RE: 6-8-2022 MEETING AGENDA ITEM #1

CONSIDERATION AR22-0001 ARCHITECTURAL REVIEW APPLICATION

CPAH PLAMBECK GARDENS HIGH DENSITY RESIDENTIAL HOUSING

FROM: JOHN & GRACE LUCINI

We have included a copy of Plan Map 3.01 with our notations.

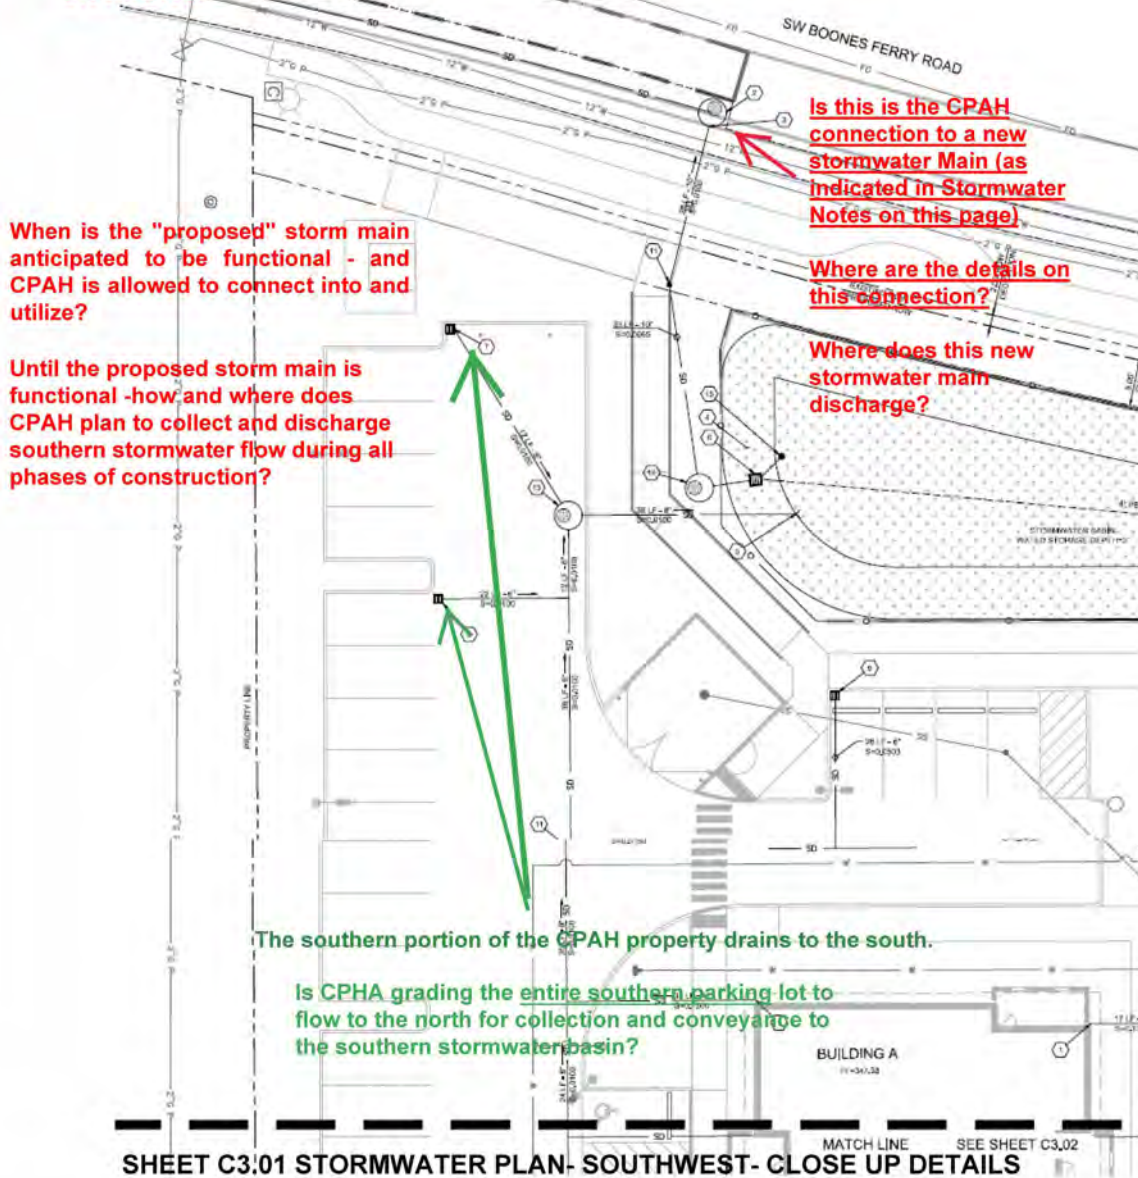
There appears to be conflicting information between these statements within **the 5-2-22 Drainage Report Southern Basin** information ----and the **Plan Set Map C3.01 Stormwater Plan Southwest** (both on the map and in the accompanying Stormwater Notes) submitted for the ARB 6-8-22 meeting.

**PLEASE PROVIDE CLARITY** The multiple AR-22-0001 documents provide conflicting information

The Preliminary Storm Drainage Report Revised 5-2-22 page 7 -Southern Basin states 'planned connection to a 12" existing stormwater system within Boones Ferry Road.'

- WHERE IS THIS EXISTING PIPE IDENTIFIED ON THIS STORMWATER PLAN?
- WHERE DOES THIS EXISTING 12" PIPE DISCHARGE?
- THIS PLAN SHEET'S STORMWATER NOTE #2 STATES- CONNECTION TO NEW PUBLIC STORMWATER MAIN- BUT LACKS WHERE THIS NEW MAIN WOULD DISCHARGE

When is the "proposed" storm main anticipated to be functional - and CPAH is allowed to connect into and utilize?

Until the proposed storm main is functional -how and where does CPAH plan to collect and discharge southern stormwater flow during all phases of construction?

Is this the CPAH connection to a new stormwater Main (as indicated in Stormwater Notes on this page)

Where are the details on this connection?

Where does this new stormwater main discharge?

The southern portion of the CPAH property drains to the south.

Is CPAH grading the entire southern parking lot to flow to the north for collection and conveyance to the southern stormwater basin?

**SHEET C3.01 STORMWATER PLAN- SOUTHWEST- CLOSE UP DETAILS**

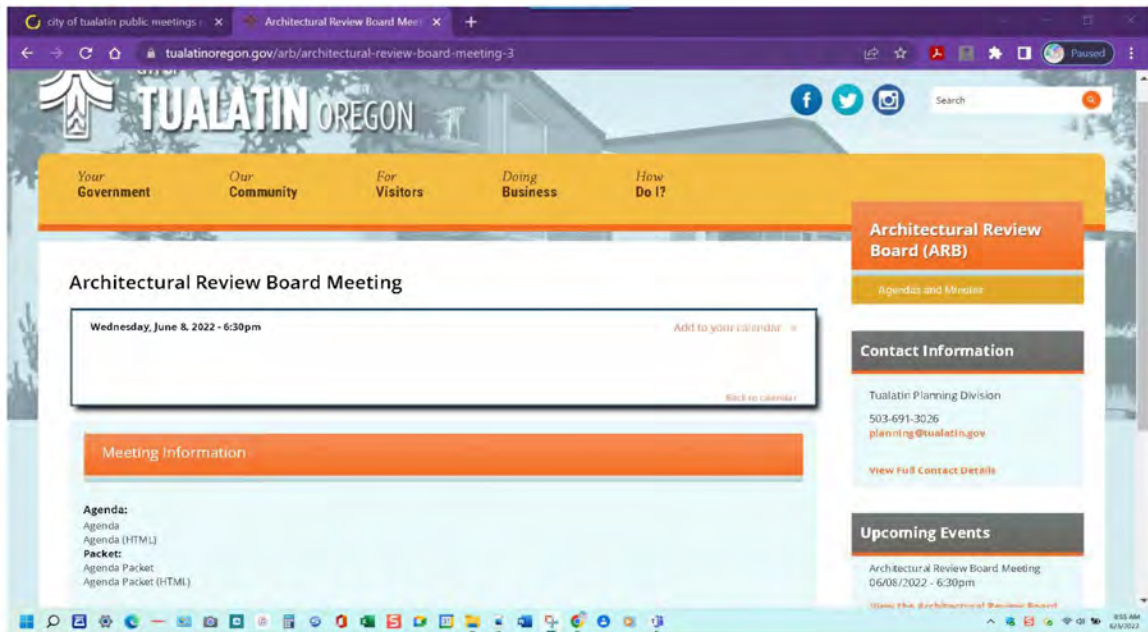
The SW Stormwater Plan Map 3.01 provided with the ARB submission does not provide information as to the location or diameter of the existing pipes referenced in the Drainage Plan- which is necessary to understand how CPAH is intending to convey stormwater runoff or overflow from the southern half of their property.

In addition, the SW Stormwater Plan Map 3.01 indicates use of a "connection to new public stormwater main"

Please provide clarification as to which and where CPAH is intending to discharge the southern stormwater

1. Will an existing pipe be used (as stated in the Drainage Report 5-2-22)?

A. If so, please clearly identify which one of the existing pipes will be used to convey the stormwater flow from the southern portion of the CPAP property offsite.

B. Please clearly identify where this pipe discharges.

4. As the stormwater flow from the southern portion of the CPAH property flows south, Plan Sheet C3.01 indicates intake connections of stormwater runoff from the southern parking area centrally located in the parking area.

How does CPAH plan to collect the parking lot runoff south of these two intakes into the proposed system which is uphill?
